WATER RESOURCES INTEGRATION PROGRAM, PHASE 1 PIPELINE SEGMENT 2B

SAWS Job No. 14-8606

ADDENDUM NO. 1

SEPTEMBER 17, 2014

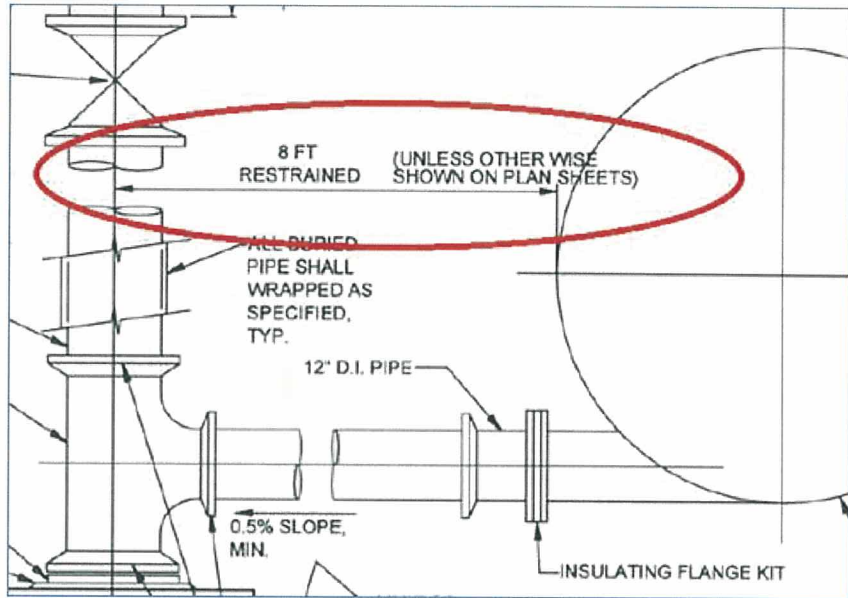
2. Detail Sheet DT06, Section view, Remove the note “SEE PLAN SHEET FOR REQUIRED DISTANCE” located between the transmission main and the vertical riser pipe and replace it with the “8 FT RESTRAINED (UNLESS OTHERWISE SHOWN ON PLAN SHEETS)” as indicated in the following drawing excerpt:

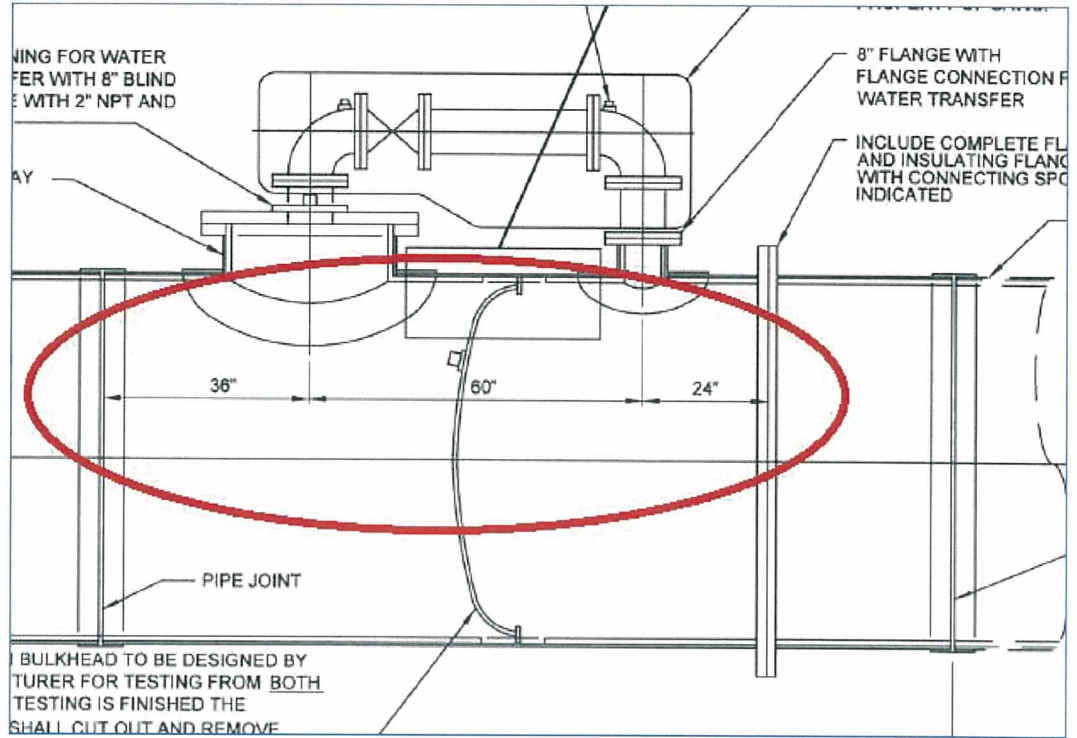
4. Detail Sheet DT10, Add fitting dimensions to the section view on this sheet in accordance with the following drawing excerpt:
